Environmental Impact Assessment

ERA Reference no.:	EA 00004/24
PA Reference no.:	PA 07562/23
Project Title:	To demolish existing garages and stores, reclaim quarry to previous 1967 topographic levels, construct four residences and restore scheduled areas
Location:	Hardstone Quarry, No. 30, Triq Panoramika, Ta' Żuta, Siġġiewi.
Screening date:	14 February 2024

Figure 3: Proposed block plan. Source: E-Apps PA 07562/23 Doc 11d.

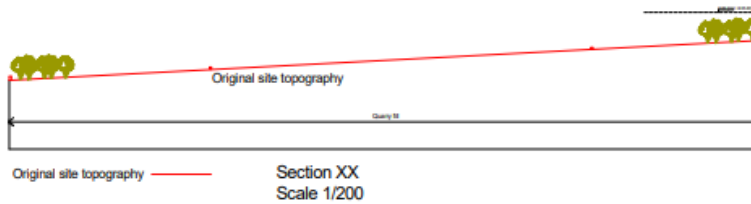
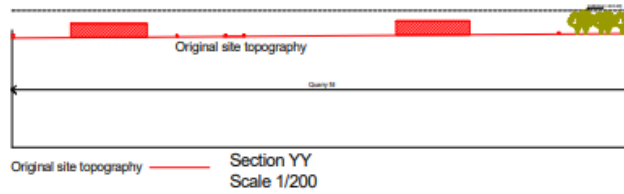
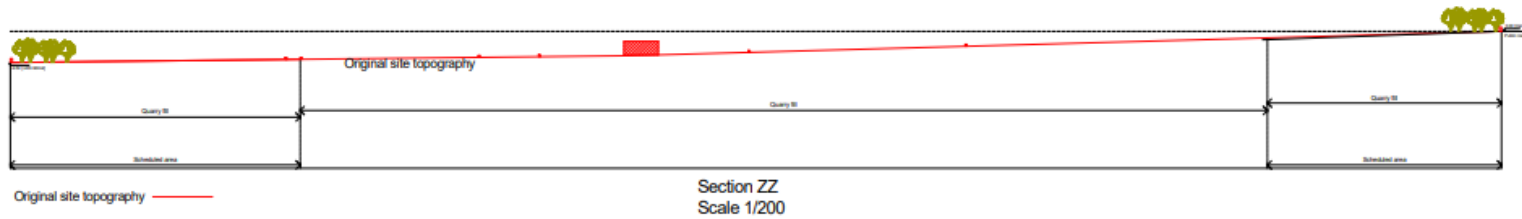
- 6.1 The ERA notes the improvements made following the discussions held on previous applications (refer to Section 3 above), particularly the elimination of industrial after-uses and underground parking. Whilst these are positive, the layout of the four residential units should be less scattered to limit the sprawl of the proposed development on site.

- 6.8 The inclusion of landscaping is considered beneficial however the current proposal envisages a relatively formal linear arrangement along the site boundary. A more 'organic' planting layout with trees clustered strategically within the site and particularly around the proposed structures is recommended. This will provide more effective integration into the surrounding natural landscape. The species used are to be representative of the natural ecosystems characterising the surrounding environment.

- i. Revised plans to limit sprawl of the proposed development on site;
- ii. A Restoration Method Statement for the backfilling phase. Refer to TORs in Annex II;
and
- iii. An updated Landscaping Plan.
